ZRD1: Zoning Resolution Determination Form

Street Name West 34th Street (AKA 55 Hudson Yards)

55 HUDSON YARDS

NORTHEAST CORNER
LOBBY -
GROUND FLOOR PLAN

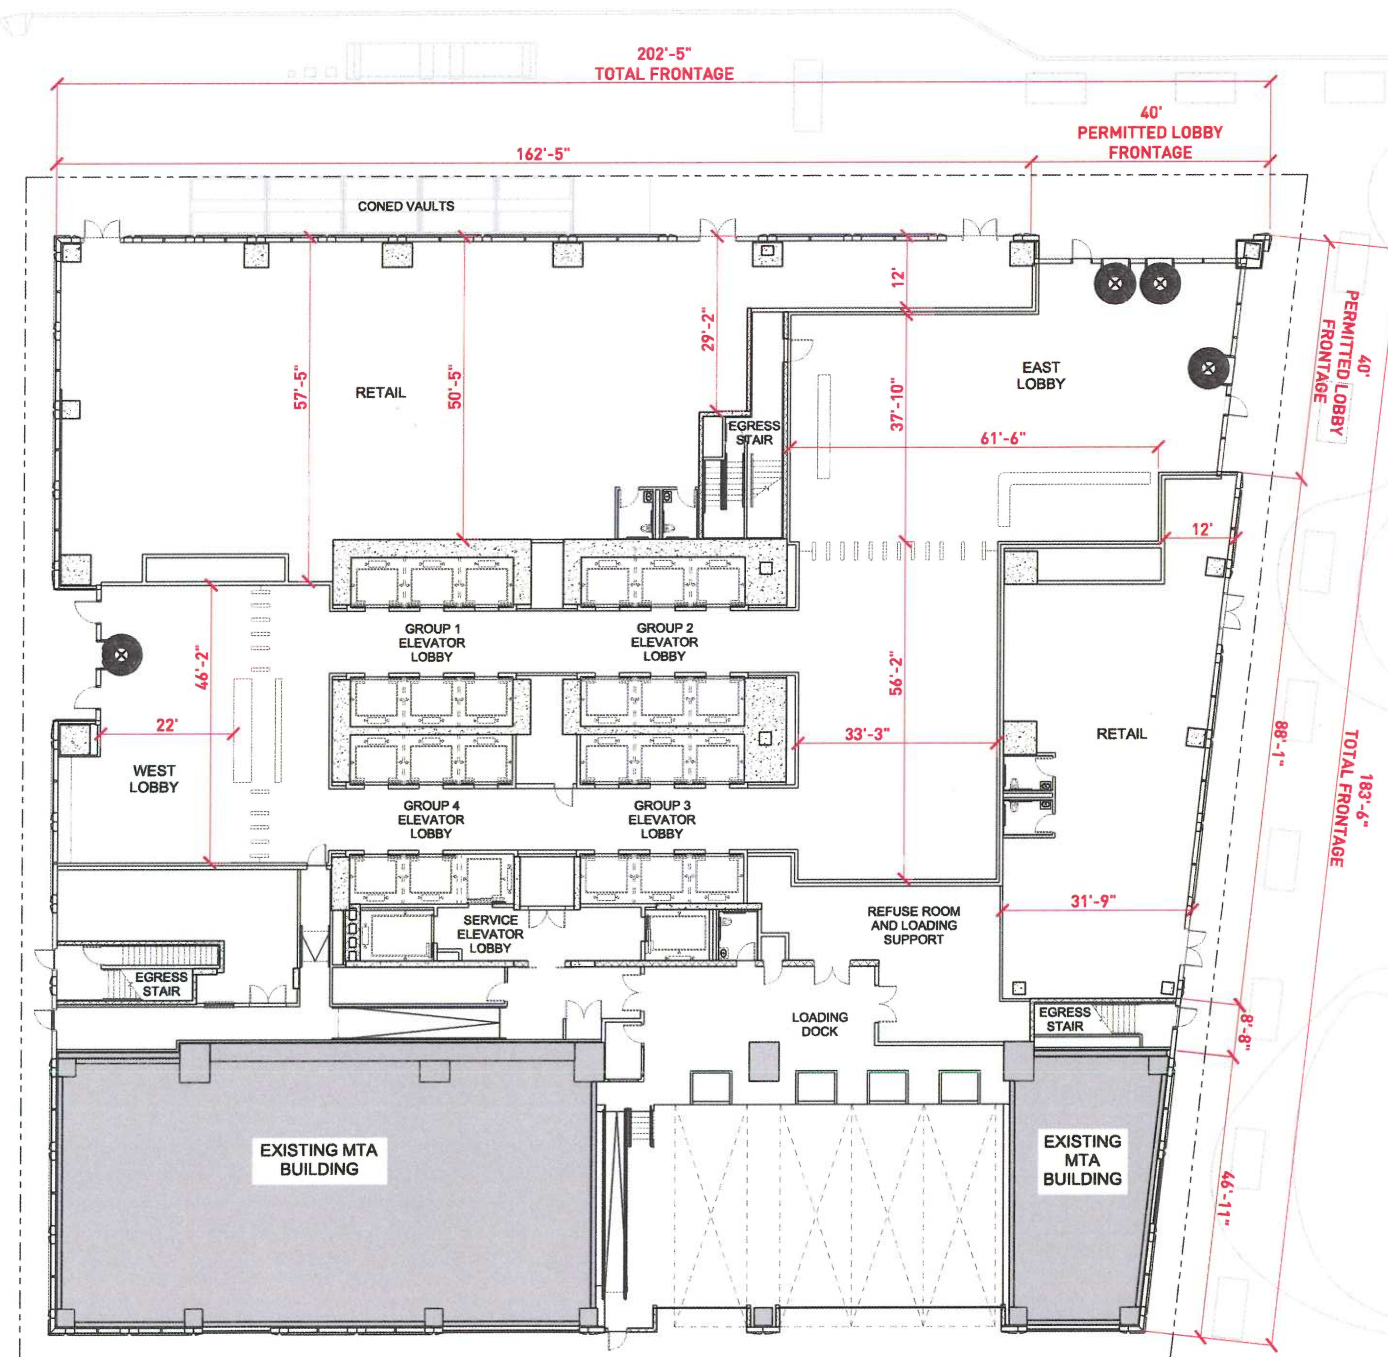
Respectfully request confirmation that the proposed ground floor plan complies with ZR Section 93-14 (Ground Floor Level Requirements) with respect to uses within 50 feet of the sidewalk widening lines along West 34th Street and Hudson Boulevard and Park.

We note that if the proposed building had two separate lobbies of 40 feet in width and 50 feet in depth along each of West 34th Street and Hudson Boulevard and Park, there would be 4000 square feet of lobby space within 50 feet of these streets. With an aggregate of only 3,668 square feet of lobby space, the proposed plan uses less of the ground floor for lobby area than would be permitted in a two-lobby scheme.H

The two minor areas behind retail space that are not lobby space are building support spaces (egress stair and refuse/loading space) that are not primary "uses" of the building within the meaning of ZR 93-14, and in the case of the refuse/loading space serves the retail uses of the building.

For the foregoing reasons, respectfully request confirmation that the attached plan (Northeast Corner Lobby - Ground Floor Plan by KPF, dated 5/6/15) is compliant with ZR Section 93-14(a).

The request, to determine that the proposed ground floor retail configurations fronting West 34th Street and Hudson Boulevard comply with the retail depth requirement of ZR 93-14, paragraph (a), is hereby approved.

Consistent with the ZR 93-14 (a) restrictions on permitted lobby width, the applicant has proposed a single corner lobby as opposed to a separate lobby for each of the two frontages subject to retail continuity requirements. This provides both a single primary point of access to the building in the location closest to the subway entrance/exit within Hudson Boulevard (park) and maximizes the continuous length of the retail spaces on each frontage by not breaking up each frontage with an intervening building lobby space. Because this configuration necessarily requires that the lobby retreat into the site at an angle, it is not possible to also provide a minimum retail depth of 50' along the remainder of each frontage, as to do so would sever the lobby from accessing the circulation core for the building. Accordingly, the Department views the portions of the lobby located to the rear of required retail uses as being consistent with the exemption from the 50' depth of use requirement afforded to "[...] lobby space, entryways [...]" as stated within ZR 93-14 (a) and the request is approved.
